# **Block 21 Development**

## **Community/Neighborhood Meetings and City Sponsored Public Meetings**

## INITIAL EARLY DESIGN GUIDANCE OF THE DOWNTOWN DESIGN REVIEW BOARD

Project Number: 3018578

Figure 5. The Commission asked for greater detail of the pedestrian experience at the several public spaces in the proposed development and along the two Green Streets.

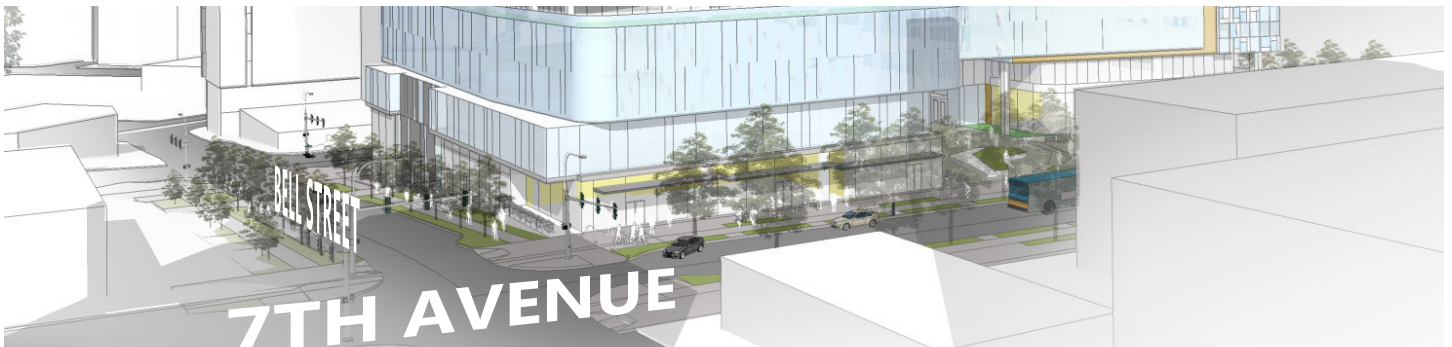
1. Continue to develop all edges of the site within the public realm with an eye to creating a usable and inviting experience for pedestrians. The diagonal connection through the site and towards Denny Park is an improvement to the urban fabric provided it does not come at the detriment of the street-facing edges of the project.
2. Given their Green Street designation, look particularly closely at the pedestrian experience on Bell and Blanchard Streets, grade challenges notwithstanding. Examine how transparency requirements create opportunities to engage pedestrians on these streets.

3. More clearly define the quality and vocabulary of the public spaces created, especially at the corner of 8th Ave and Bell St (Figure 6). The Commission struggled to understand its relationship to the public and private portions of the site. Continue to include ADA accessibility as part of the solution to the grade change.
4. Given the grade change from north to south, ensure that sightlines make it obvious to a pedestrian that the diagonal through-block connection is a continuous and publicly accessible connection through the site.

**Figure 1.** Proposed design for 8th Ave. The Commission was concerned about the stair and recessed bike entry outlined in orange.

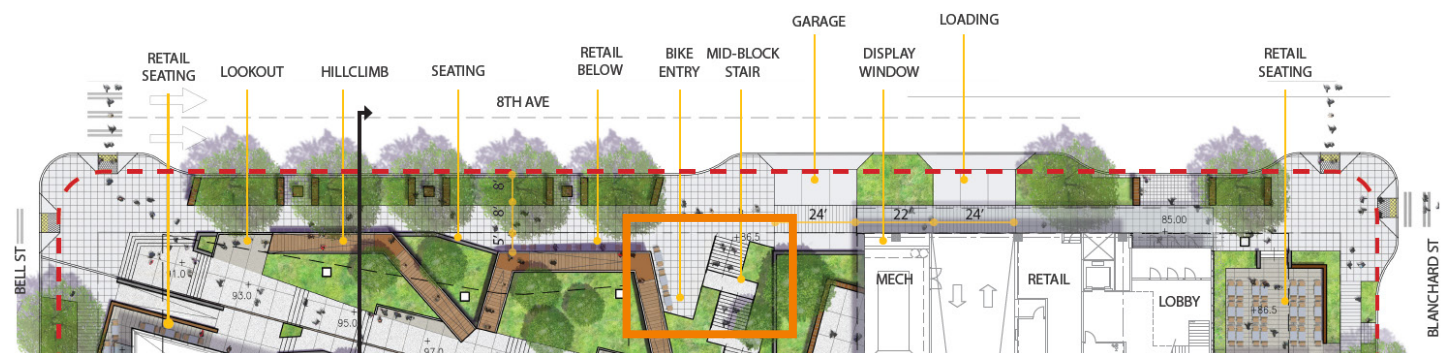
However, the Commission remained concerned about the two curb cuts proposed on 8th Ave. The Commissioners believed the presentation had not contained enough information to support this solution over a different approach with less impact on the pedestrian realm, and based on the previous presentation from March 5, 2015, there was some confusion about the proposed turn movements in and out of the garage. The Commission recommended fur-

ther study of options for access that would minimize the impact on the public realm. The Commissioners were also concerned about the recessed entry to the bicycle storage, outlined in Figure 1, and recommended the petitioner explore creating a more generous stair at mid-block.
